TSB130099

ISX12 CM2350 X102 and ISX15 CM2350 X101 Compatible SCR Catalyst Part Number Required with Calibration Update

Figure 1, There are identifying dimples in the heat shield of the compatible SCR catalyst. These dimples go all the way around the SCR catalyst. They can be found in 3 different places around the circumference.

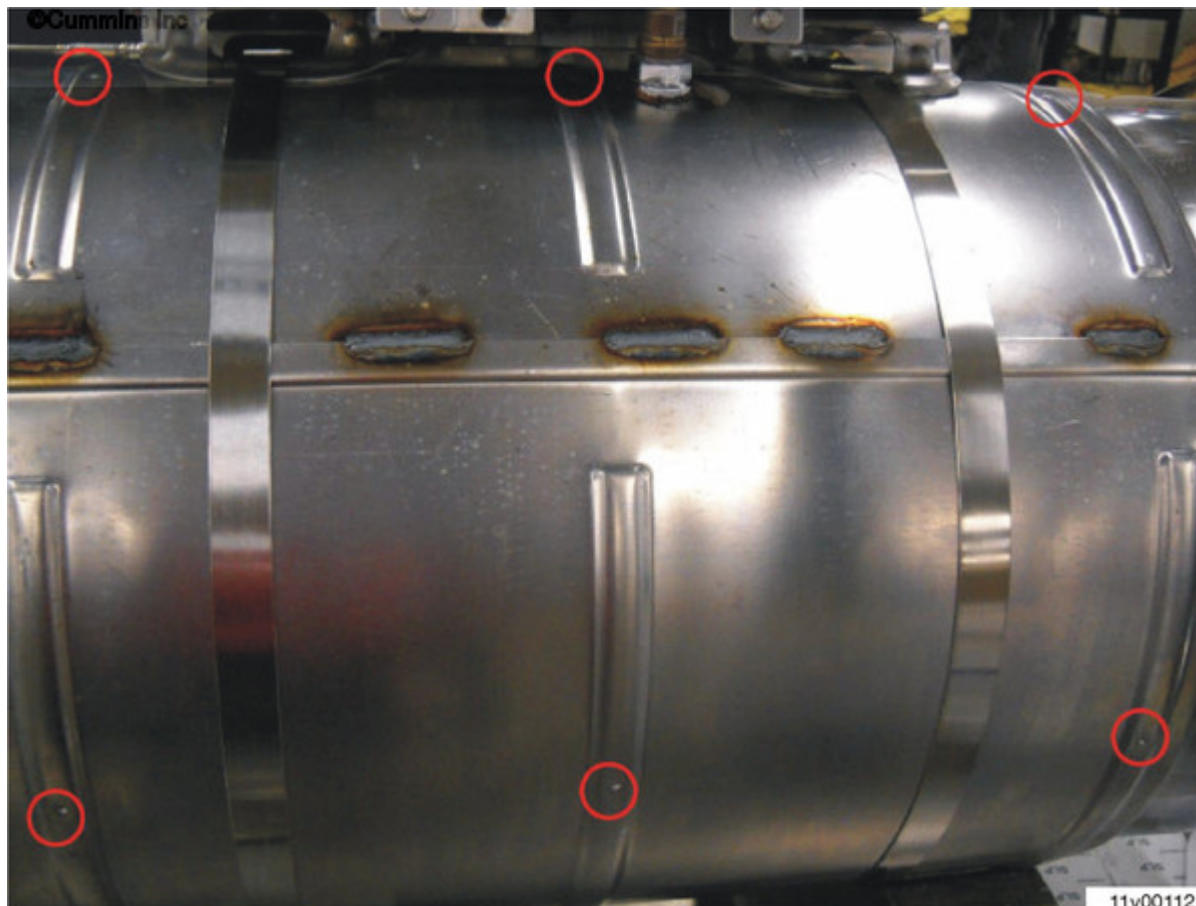
Calibrations released after June 21, 2013 will require a compatible selective catalytic reduction (SCR) catalyst part number to be installed.

If the calibration in the engine control module (ECM) needs to be updated to a revision higher than what is listed in Table A, the compatible SCR catalyst **must** be verified as per Figure 1.

How to visually inspect for the SCR catalyst that is needed with an updated calibration:

If the unit does **not** have the compatible SCR catalyst as described above, reference Temporary Repair Practice 1479 in QuickServe® Online to check and/or replace the SCR catalyst at the time of ECM recalibration.

If a compatible SCR catalyst needs to be ordered, please reference the part number cross reference in Table B:
